Re: Shootaring Canyon Uranium Mill Amendment Request for Radioactive Material License
No. UT 0900480, 2nd Round Interrogatory Responses

INTERROGATORY R313-24-1(3)-02/02: SUMMARY OF REGULATORY REQUIREMENTS

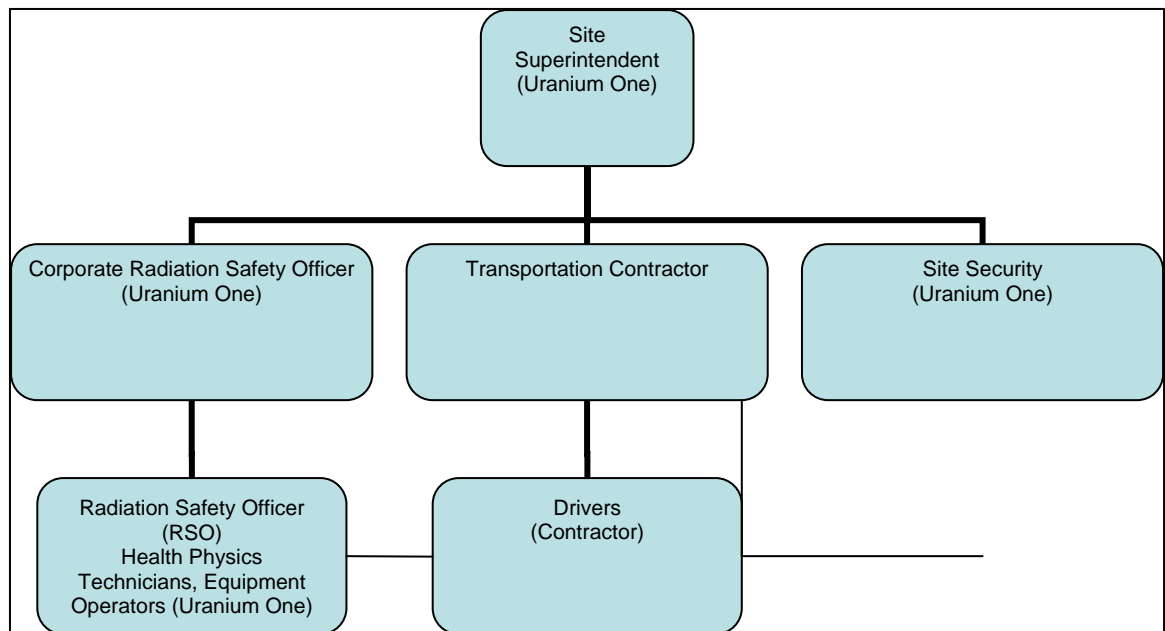
3. *Appendix A, Section 5.2: Provide an organization chart that shows relationships among the positions identified in the Transportation Plan.*

Response 3

Revised Appendix A, Section 5.2 language is proposed below.

The following is the Transportation Plan organization chart. Roles not identified in Section 5.2 of the Transportation Plan, but identified in the chart are: Transportation Contractor, Drivers, Site Security, Health Physics Technicians, and Equipment Operators.

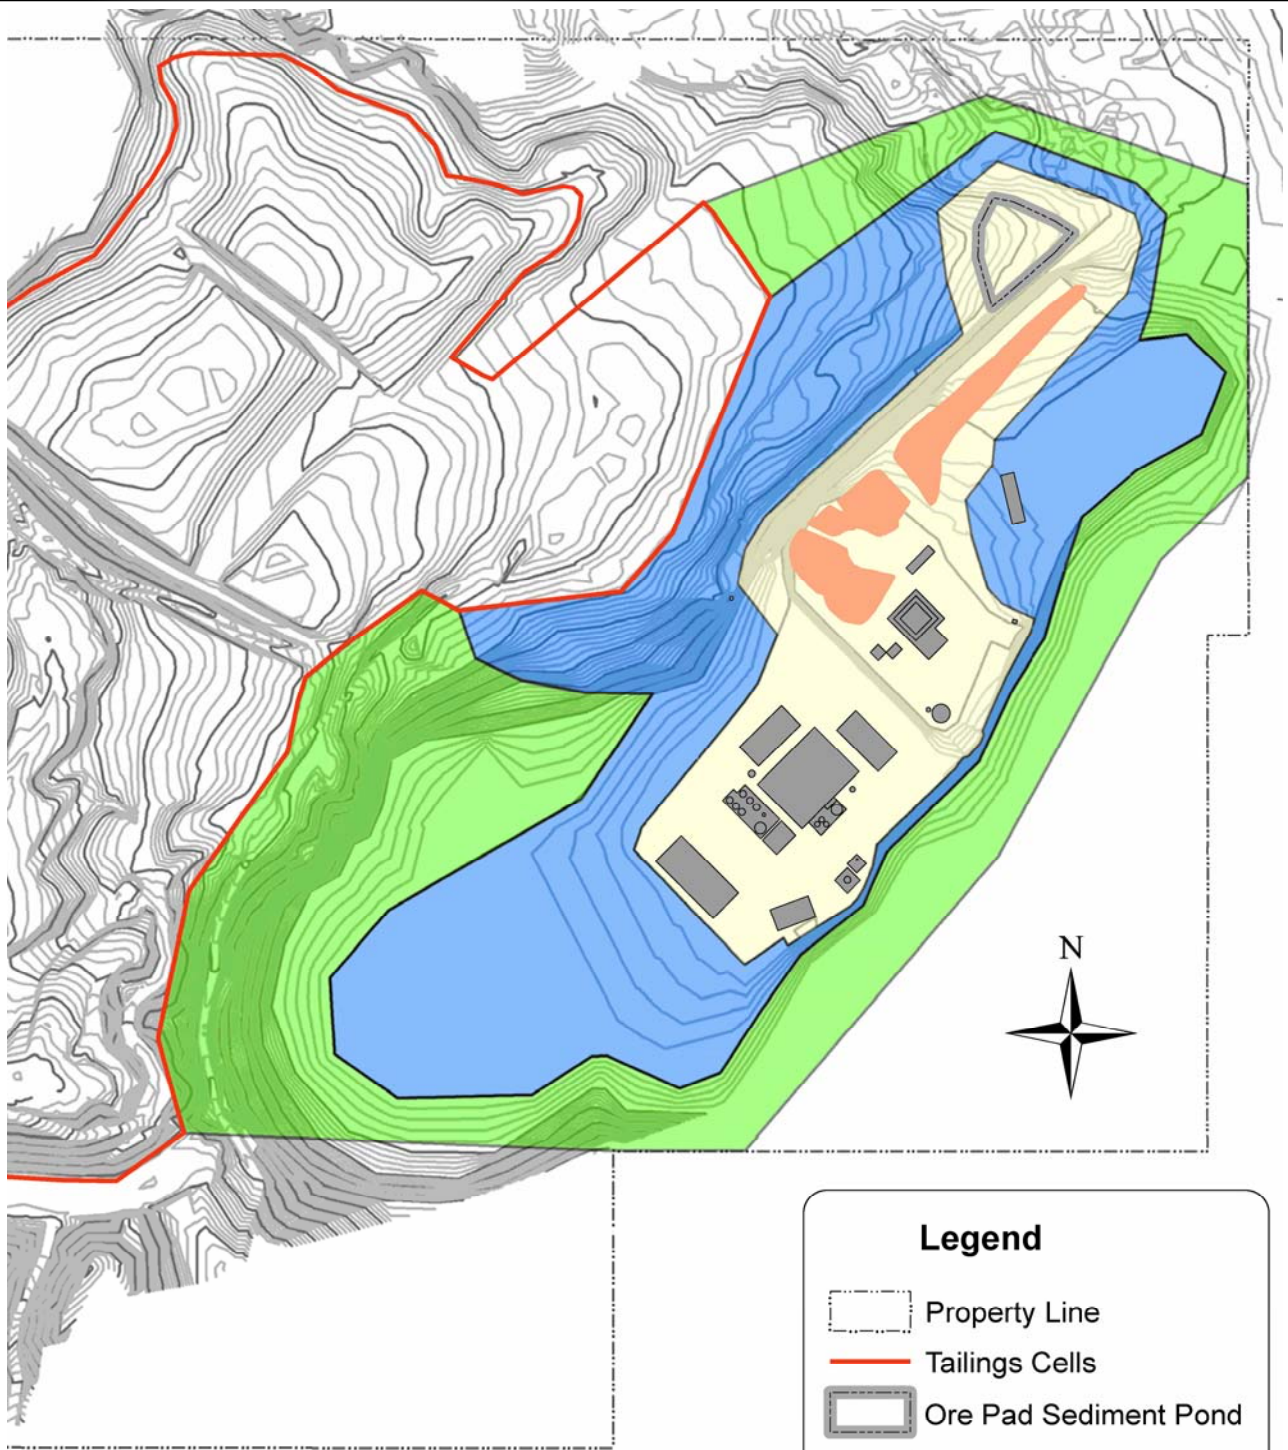
Please revise the Tailings Reclamation and Decommissioning Plan (TRDP) to include currently projected MARSSIM classifications for surface soils outside of the tailings area at the Shootaring Canyon facility. Please identify possible MARSSIM classifications for surface areas across the property under control of Plateau Resources, Ltd.

Please revise Section 3 of the TRDP to state which areas have been, or may be, classified as MARSSIM Class 1, 2, and 3 areas and include maps in Section 3 to identify and delineate these areas. Please provide clear definition of “known” Class 1 and 2 areas that presently exist.

Section 3 of the TRDP does not state which areas have been, or may be, classified as Class 1, 2, and 3 areas and the maps in Section 3 do not show these areas. It would be helpful to provide clear definition of “known” Class 1 and 2 areas to describe current conditions and modify Section 3 where appropriate to refer to Section 8.4 for additional description of protocol for cleanup and survey classification determinations.

Figure 8-1 has been developed in response to the interrogatory. Proposed text and figure changes are presented below.

Figure 8-1 shows probable MARSSIM Class areas for the site at the end of the operating period. It is reasonable to assume that soils within the mill yard, the ore storage area, and the ore pad sediment pond will have residual contamination approaching or exceeding the cleanup criteria and therefore these areas are shown as Class 1. Class 2 areas include roadways and areas adjacent to the Class 1 areas that are expected to contain residual material but may not exceed the cleanup criteria. The Class 3 areas shown in Figure 8-1 will require some investigation but are not expected to be contaminated. These areas will require further investigation.

**FIGURE 7-1
LOCATION OF HYDROLOGIC FEATURES**

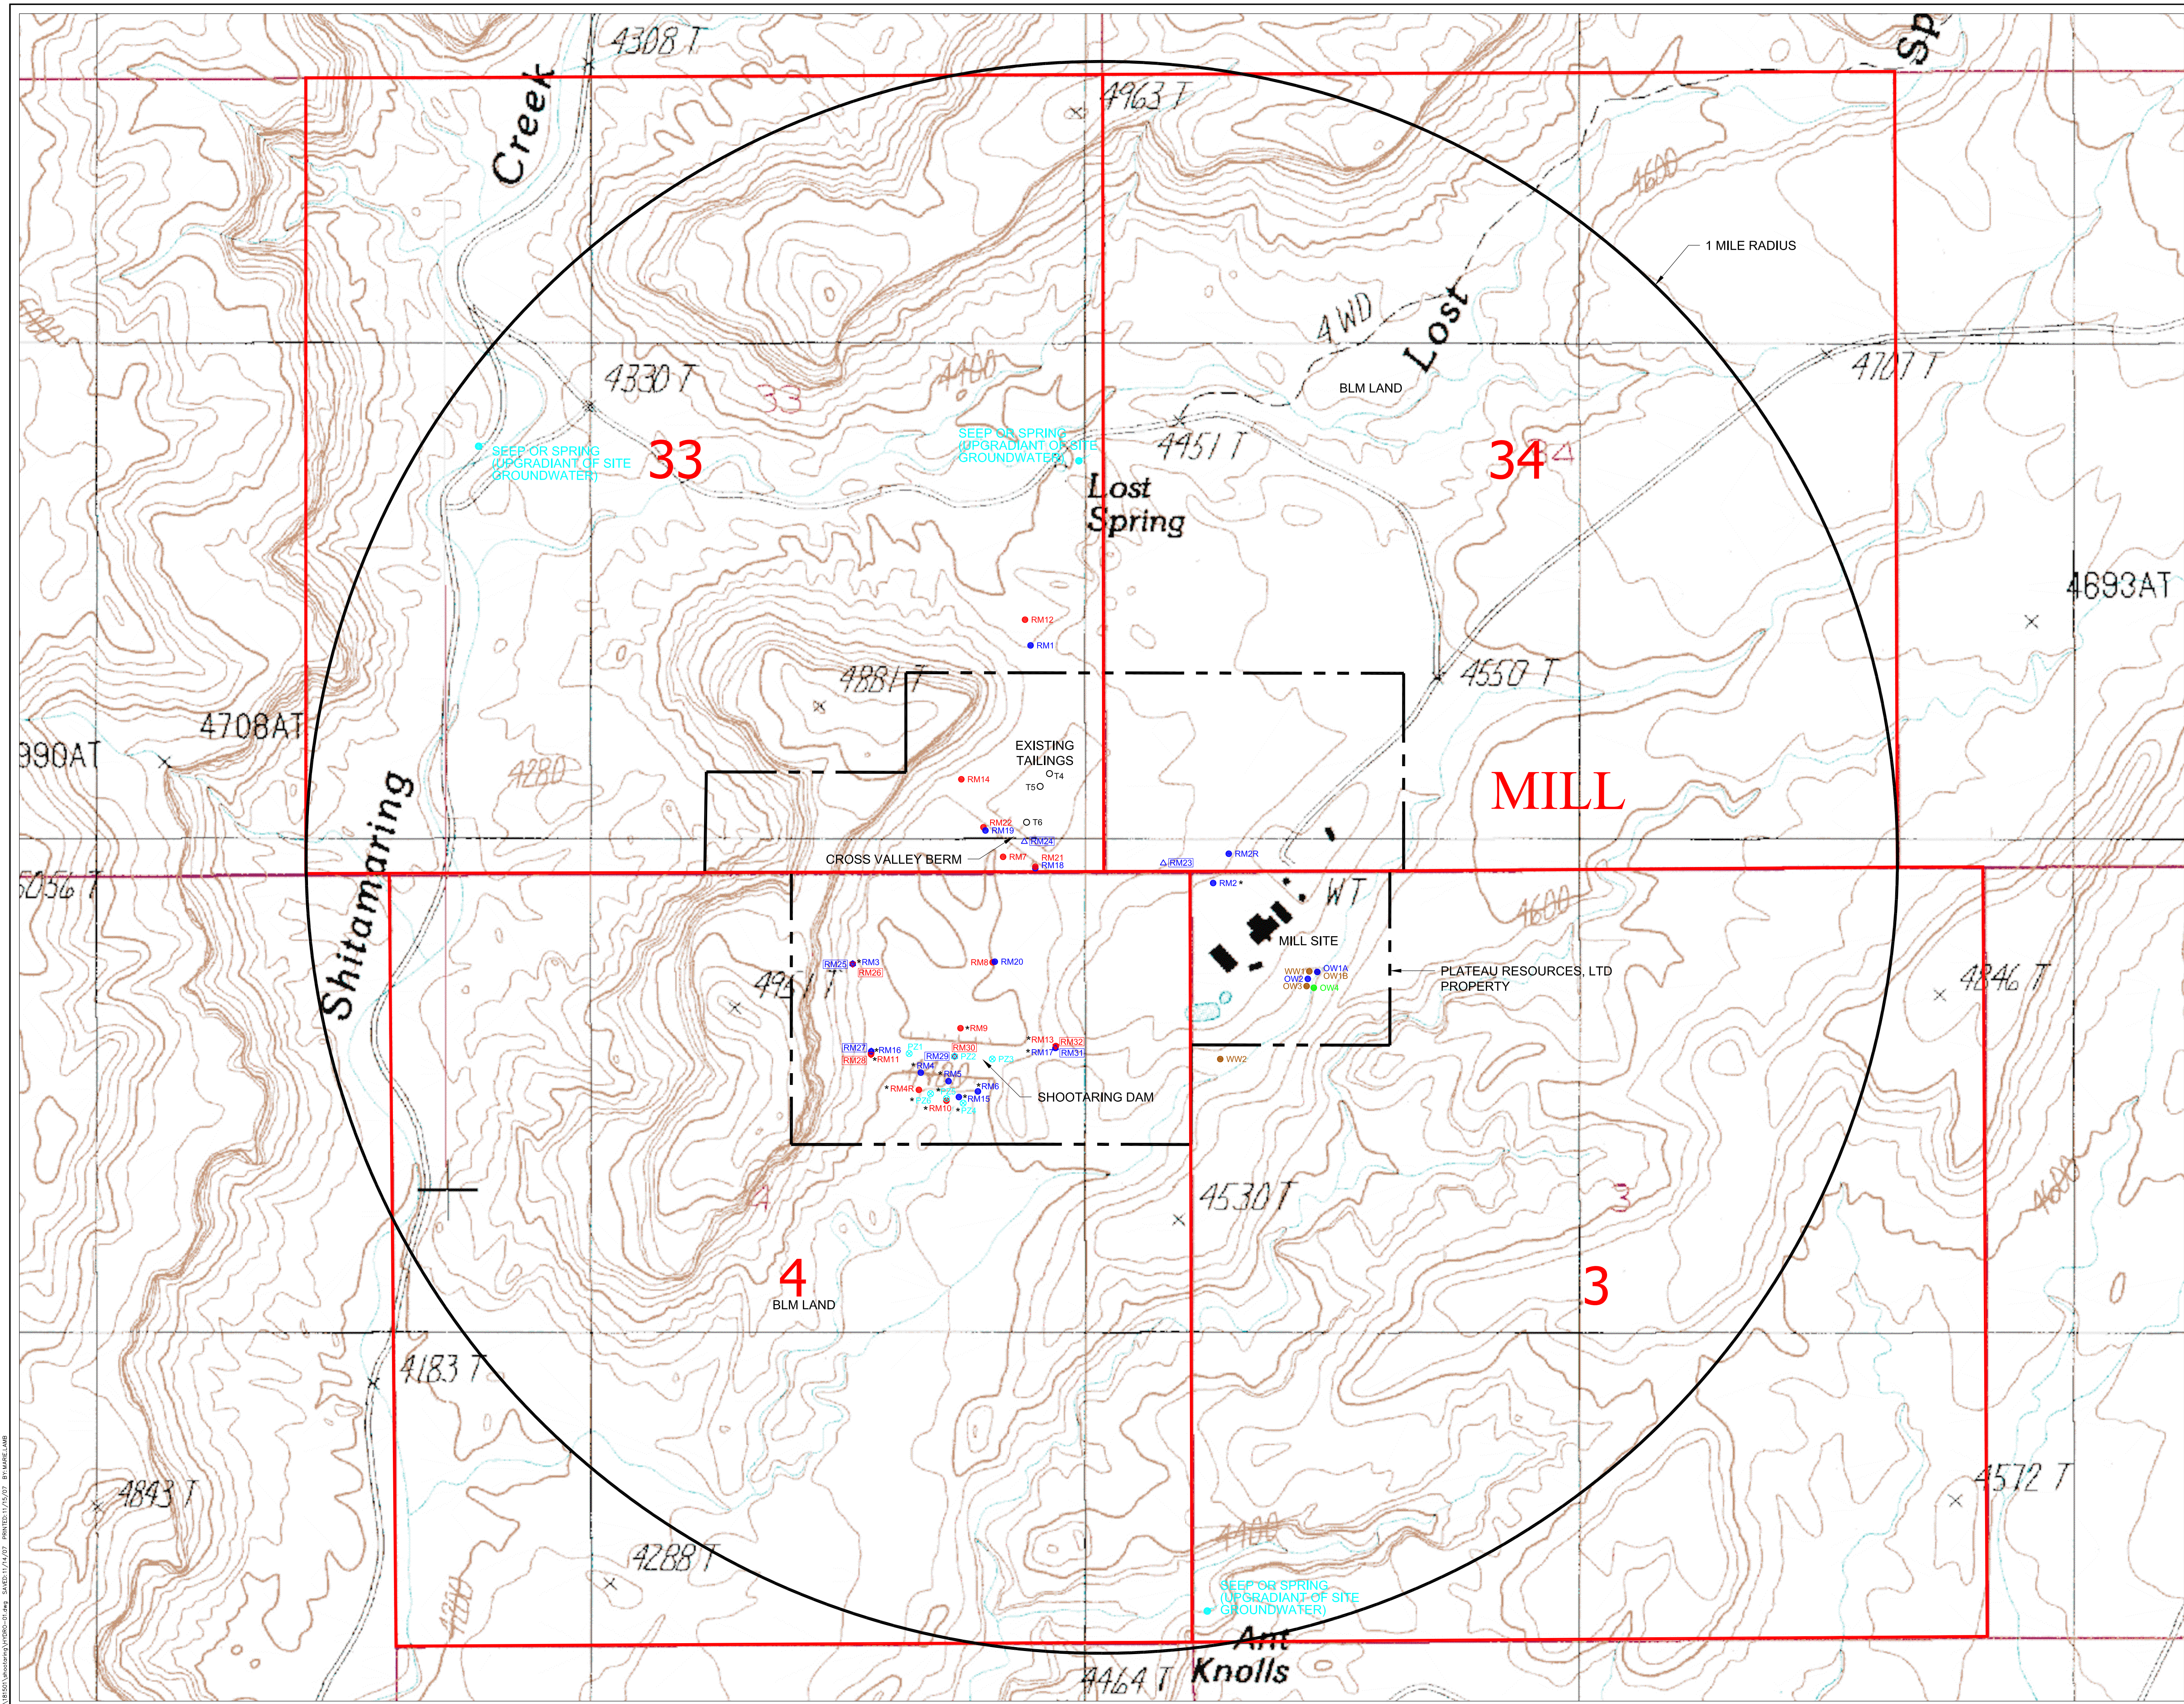
Please state the status of each well and seep shown in Figure 7-1 of the TRDP. Tie Figure 7-1 into the local survey plat. Include in Figure 7-1 information about the area within a one mile radius of the discharge point or within one mile of the perimeter of the tailing ponds. Include true and magnetic north, with declination and date of declination measurement. Refer to the preliminary findings stated above to ensure the Uranium One provides complete details that should be included in the plat. If a specific item from the preliminary findings is not applicable, clearly state this in both the response and text accompanying the revised Figure 7-1.

Figure 7-1, as provided contained in the TRDP revised December 2006, does not meet the June 2006 interrogatory request (repeated below for convenience).

The attached Drawing 7-1 will be added to the Tailings Reclamation and Decommissioning Plan. This drawing includes all of the requested data.
